RE: MARRIOT HOTEL AT WINROCK MALL – DRB SUBMITTAL FOR SITE PLAN FOR BUILDING PERMIT

DRB PROJECT NUMBER: PR –2018-001579

Subsequent to comments provided at the DRB Hearing on November 20, 2019 we have the following written responses as well as the accompanying revised documents and drawings. We look forward to reviewing with you at our next scheduled hearing on December 18, 2019.

14 TYPICAL STREET SIDEWALK
NTS

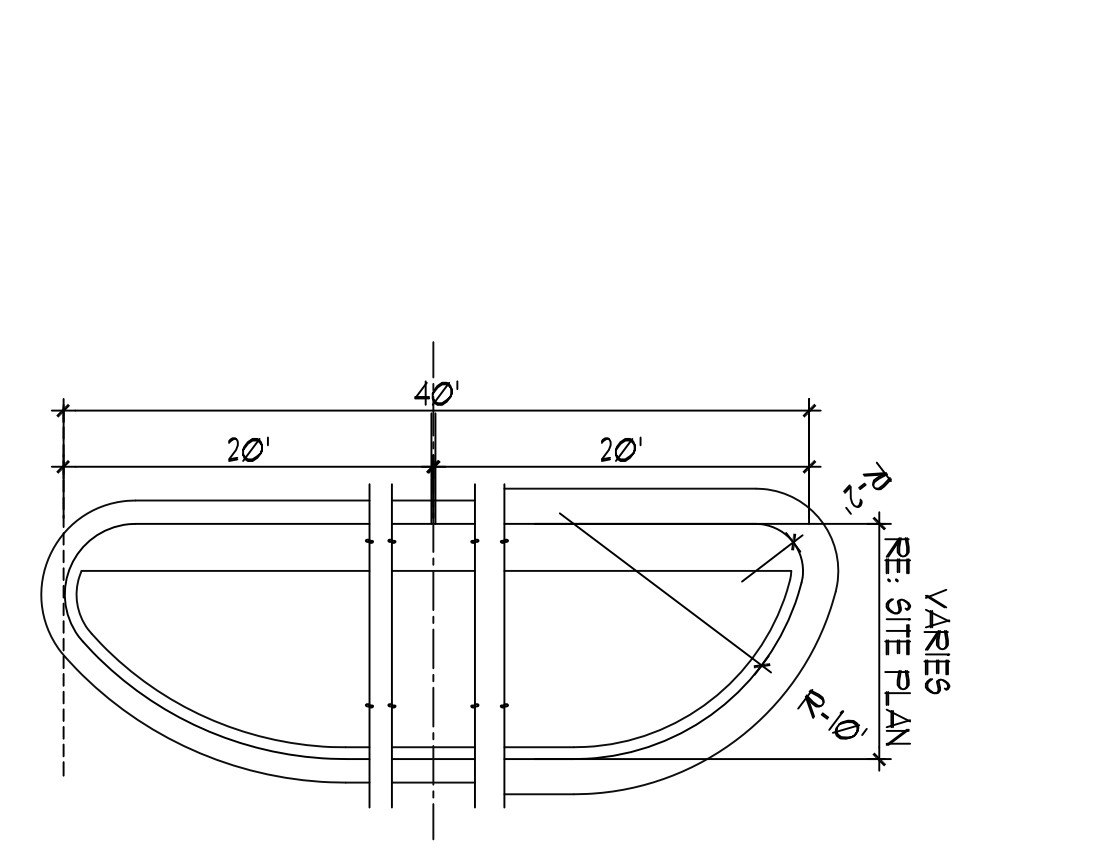
4. The "Typical Street Sidewalk" should be a minimum of 6 inches in thickness, and follow the COA Standard Specifications to support vehicular traffic.

- a. Addressed:
 - i. See A1.1 Site Details: Note 7
5. Provide a street cross-section for the street east of the hotel development with any reconstruction, and provide a copy of the final plat. (Generally, any roads built within public roadway easements or right-of-way dedication to the City of Albuquerque require a work order.)

21 LIGHT POLE DETAIL
NTS

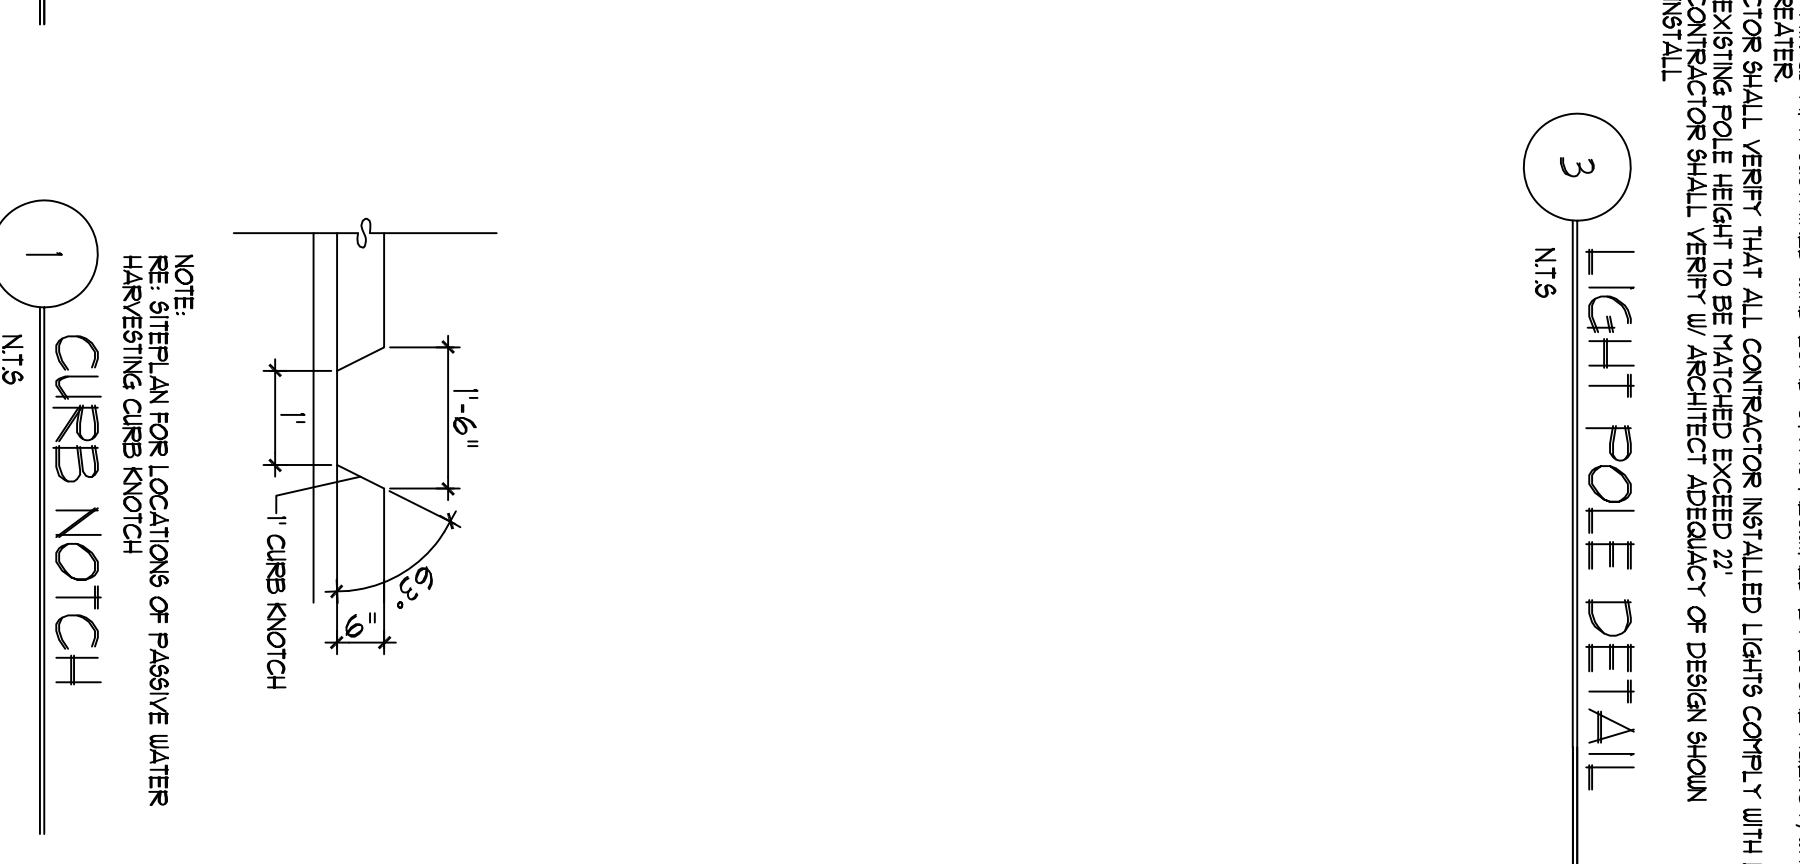
- a. Addressed:
 - i. Sheet SP-1A2: Site Data Table
 - ii.
5. Per 5-8(D).(7.), the maximum height of light poles in a mixed zone district is restricted to 20 feet in height, but the height of the light poles in the plans is 25 feet in height, which is five feet higher than the maximum allowed.

- a. Addressed:
 - i. Sheet SP-1A2: Key Note 2
- 6. Make sure that 5-11(E.)(2.) of the IDO regarding façade design is being met.
 - a. Addressed:
 - i. Per the ruling from James Aranda, Deputy Director/Planning Department:

TITLE: **GRADING PLAN FOR DRB SITE PLAN**

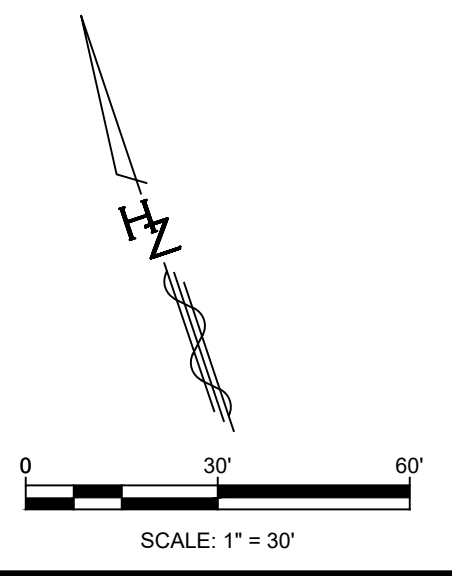
1. An approved Conceptual Grading and Drainage Plan is required.
 - a. Addressed:
 - i. See Sheet C100 – Drainage Plan
 - ii. See Sheet C102 – Grading Plan for DRB Plan
